## Modifications Proposed by BPAC to Final Draft ATP

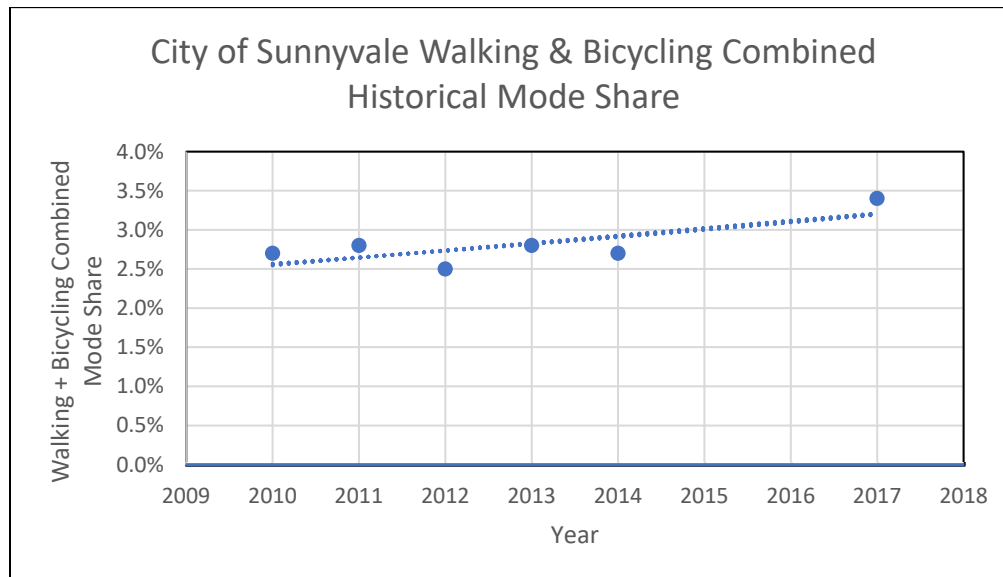
**BPAC 1.** To target a minimum of 1% increase in active transportation mode share per year (including bicycle, pedestrian, and alternative transportation such as scooter).

*Staff Response:* The following figure presents the historical combined mode share trend for Sunnyvale commuter ages 16 and older who commute to work by biking or walking. The data was obtained from the US Census Bureau (<https://data.census.gov/cedsci/>) and the Santa Clara County Health Department.

Based on historical data (Year 2010-2017), the change in the combined mode share for Sunnyvale commuters who walk or bike to work ranges from -0.3% to +0.23% each year. Staff feel that the Year 2030 goal of achieving a 5% bicycle mode share is more aggressive than our historical trend but could be achievable. BPAC's proposed 1% increase in active transportation mode share per year is not a realistic goal given that the mode share has increased less than 1% in the past seven years.

This modification as proposed by BPAC is not included in the Staff Recommendation.
